**Response to Fifth Request for Additional Information Regarding ANP-10285P, "U.S. EPR Fuel Assembly Mechanical Design Topical Report"**

**Response to Fourth Request for Additional Information – ANP-10285P  
“U. S. EPR Fuel Assembly Mechanical Design Topical Report”**

**Response to Fifth Request for Additional Information – ANP-10285P  
“U.S. EPR Fuel Assembly Mechanical Design Topical Report” (TAC No. MD7040)**

Figure RAI 52-3 Normalized DNBR and FCM to SAFDL for US EPR FSAR 15.4.2 UCBW Event (new FSAR Figure 15.4-54)

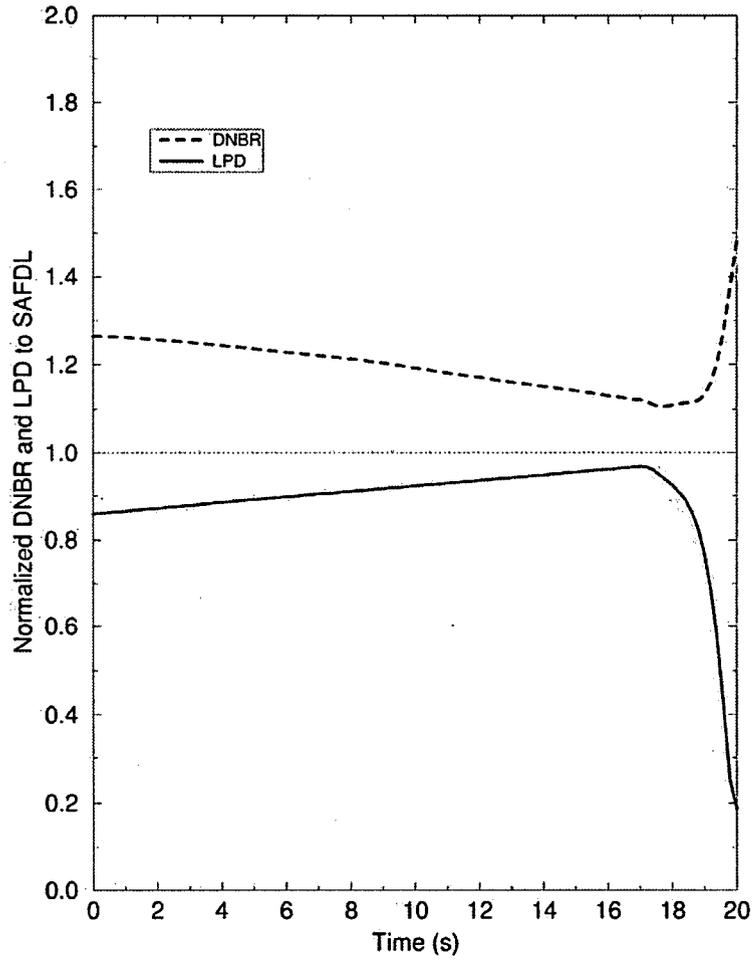
- 1. Provide the maximum LHGR limit used for cladding strain evaluation for EPR AOO events for both  $UO_2$  and  $UO_2$ - $Gd_2O_3$  fuel rods and the burnup level at which the latter limit is determined for  $UO_2$ - $Gd_2O_3$ .*

- 4. Provide predicted EPR LHGR limits for strain using a fuel mechanical design code that is validated against the latest test data and compare the results with those predicted by COPERNIC. Discuss the differences between the results and their implications.*

The most limiting AOO event for the LPD values was the U.S. EPR FSAR Tier 2 Chapter 15.4.2 uncontrolled bank withdrawal (UCBW) event. The LPD reached a level of 0.9691 relative to the trip setpoint LHGR 14.02 kW/ft for this event. Thus this event had 0.4 kW/ft margin to the limit. Figure RAI 52-2 provides the responses of DNBR and LPD relative to the limits. Because the Low DNBR reactor trip is simulated in the transient simulation as part of the protection system evaluation, the core peak power reached is 113 percent (0.9691/0.8589) instead of a potentially higher level needed to initiate a High Core Power Level trip at 117 percent with uncertainties.

A conservatism in the analysis presented in the U.S. EPR FSAR that provides margin to the limiting LHGR for 1 percent cladding strain is related to the axial power shapes used in the determination of the High LPD reactor trip setpoint. The most limiting axial power shape that was used to determine the trip threshold was from [

] and the axial power shape sets associated with this condition could be removed from consideration. If these axial power shape sets were to be removed, the reactor trip threshold could be increased to approximately [ ] W/cm ( [ ] kW/ft), indicating that the setpoint used for the U.S. EPR LHGR trip threshold provided an additional [ ] kW/ft of margin to the actual limit of [ ] kW/ft.
